NOTICE OF A PUBLIC MEETING OF THE
CITY COMMISSION OF THE CITY OF BROWNSVILLE

1. Sheet M3.4:
    a) Revised Building Chilled Water Schematic Diagram. See attached sheet.
    c) Clarification: Under the Base Bid, provide the differential pressure (DP) sensor, motorized bypass valve, and all associated materials, controls, and sequence of operation at DOAS-4. In the event Alternate #1 is accepted, this scope shall instead be provided for DOAS-5 and not DOAS-4. Provide pipes and valves sizes accordingly. Coordinate with Prime, Mechanical and Controls Contractor.

02 UPGRADES ELECTRICAL RISER DIAGRAM

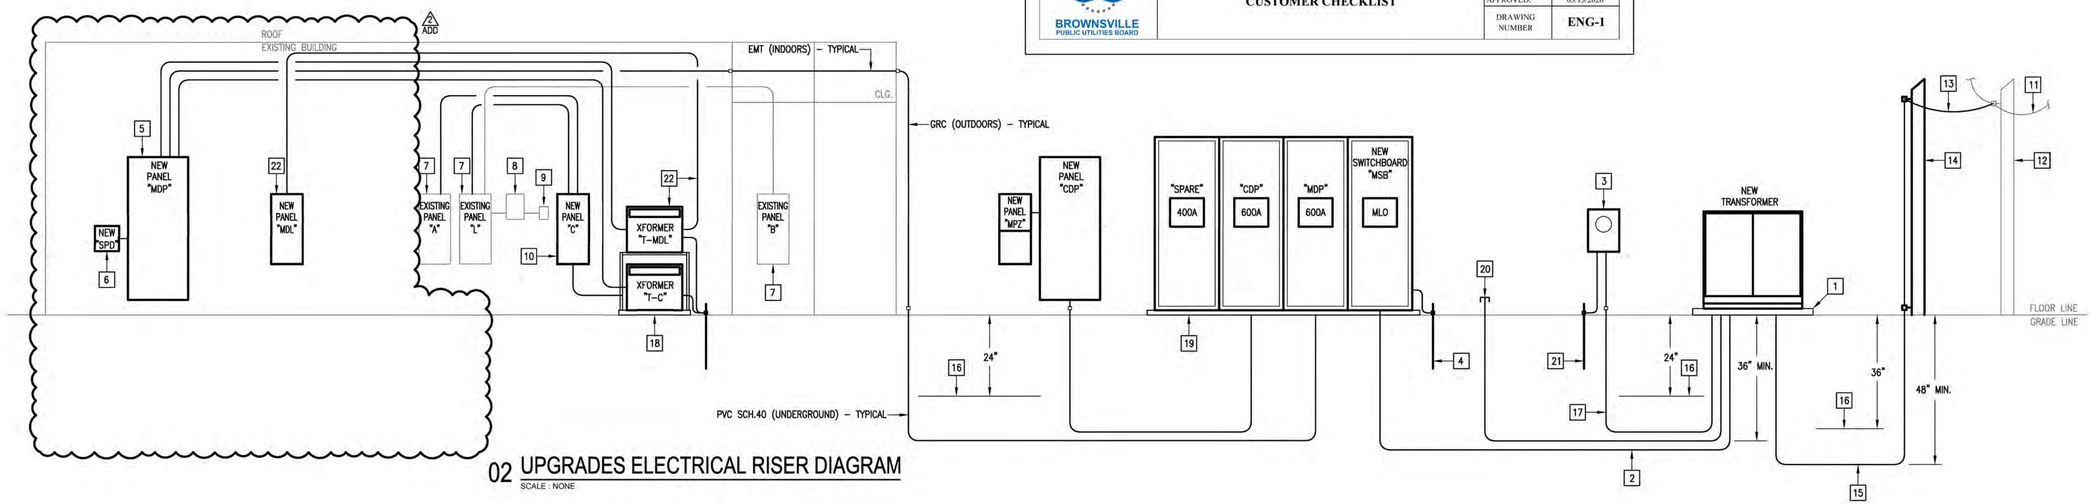
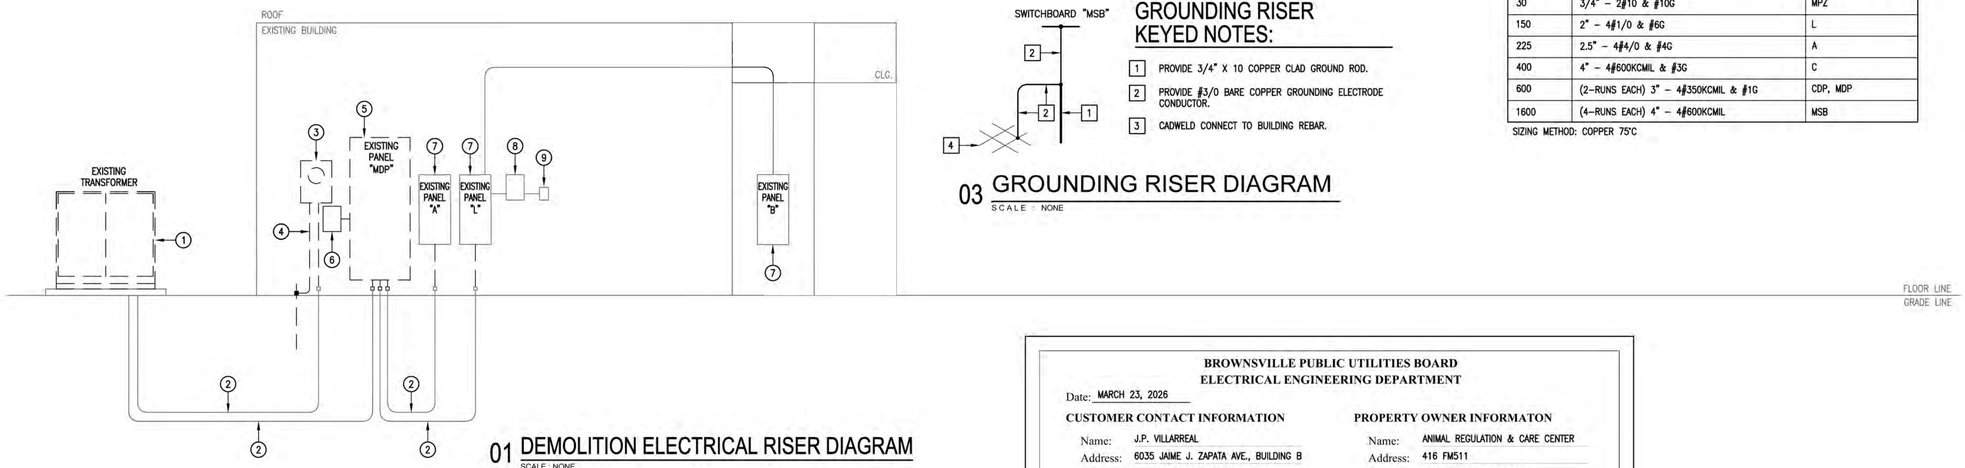
5. Sheet E4.1:
    a) See attached revised Electrical Renovation Floor Plan illustrating the relocation of Panelboard "MDP".
